PRISM™

Preliminary Safety Information Document

Volume V Appendix F

AMENDMENT 9

Figure F7.6-1

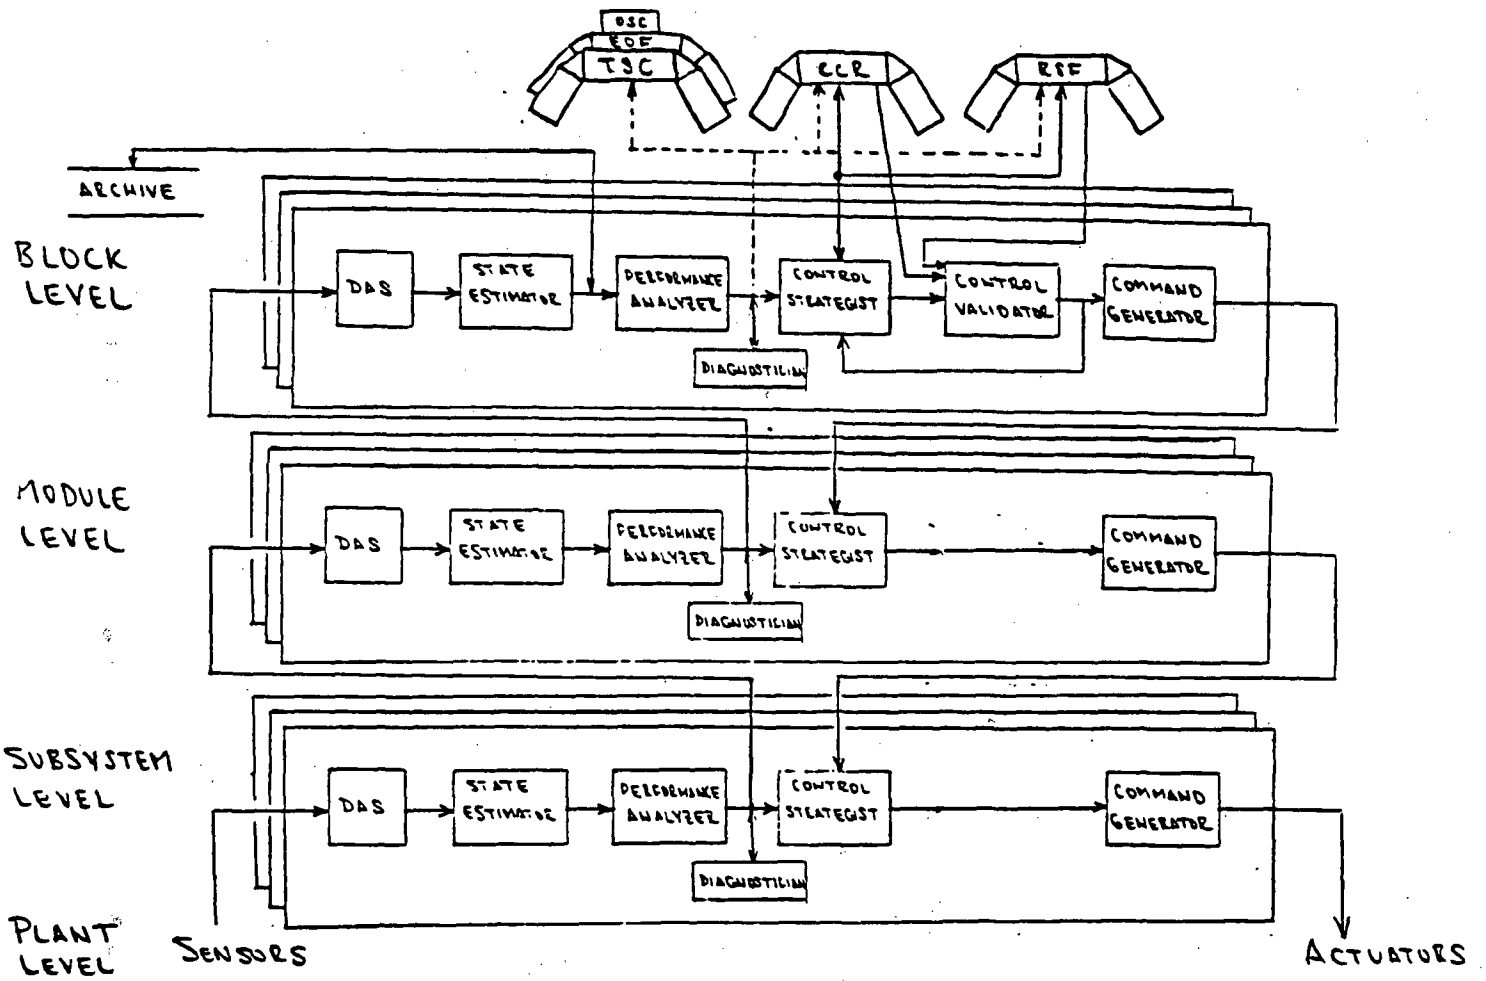
The scope of the control engine covers many functions. Identify and discuss the role of all humans required to interface with the control engine. Furthermore, map the functions identified in Figure 7.7-5, Conceptual Control Engine Model, into the hardware and functions (control center, technical support center, information and management center, remote shutdown, operations support center, administrative and maintenance offices) identified in Figure 7.7-1, PRISM Plant Control and Protection System. In addition:

An illustration of the relationship of the control engine functional interfaces with typical plant facilities is shown in Figure F7.6-1.
